APPLICATION NO.	FILING DATE	FIRST NAMED INVENTOR	ATTORNEY DOCKET NO.	CONFIRMATION NO.
10/585,378	04/06/2007	Bernhard Sixt	3787	5954
²⁷⁸ MICHAEL J. S	7590 10/06/2010 STRIKER		EXAMINER	
103 EAST NEC	CK ROAD		KOAGEL, JONATHAN BRYAN	
HUNTINGTON	N, IN 1 11/43		ART UNIT	PAPER NUMBER
			3744	
			NOTIFICATION DATE	DELIVERY MODE
			10/06/2010	ELECTRONIC

Office Action Summary		Application	pplication No. Applicant(s)				
		10/585,3	78	SIXT ET AL.			
		Examine		Art Unit			
		JONATHA	N KOAGEL	3744			
Period fo	The MAILING DATE of this communication r Reply	n appears on the	cover sheet with the c	correspondence ad	ddress		
A SHO WHIC - Exten after: - If NO - Failur Any n	DRTENED STATUTORY PERIOD FOR R HEVER IS LONGER, FROM THE MAILIN sions of time may be available under the provisions of 37 C SIX (6) MONTHS from the mailing date of this communicatic period for reply is specified above, the maximum statutory p e to reply within the set or extended period for reply will, by sply received by the Office later than three months after the d patent term adjustment. See 37 CFR 1.704(b).	IG DATE OF THE FR 1.136(a). In no evon. period will apply and w statute, cause the app	HIS COMMUNICATION ent, however

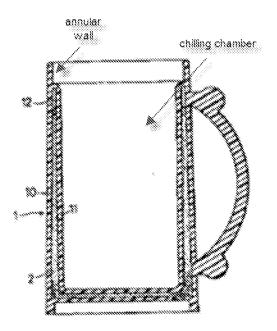
However, Yomei teaches in fig. 1, an inner container 1 has a double walled hollow cylinder 12 including an inner wall 11 and an outer wall 10, and also a bottom at one end and an annular wall (See annotated figure below) at the other end, a refrigerant chamber being formed between said inner wall 11 and said outer wall 10 and said annular wall A and said bottom, a chilling chamber (See annotated figure below) being arranged centrally and delimited by said inner wall 11 and said bottom.

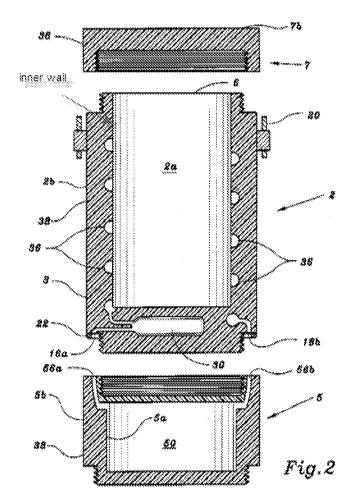
However Mosby teaches in fig. 2, an inner wall (See annotated figure below) of a cylinder 3 has a thread for an element 7 which closes a chilling chamber 2a and is selected from the group consisting of a screw cover.

Fig. 1

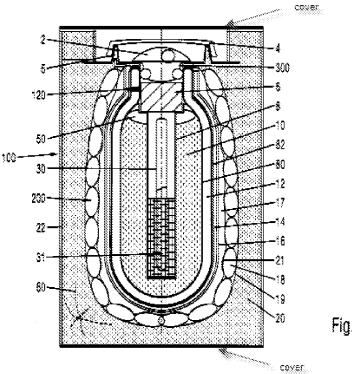
However, Mullens teaches in fig. 1, a transport container with insulation 20 surrounded by a rigid protective tube 22 having ends which are closed respectively by a cover (See annotated figure below).
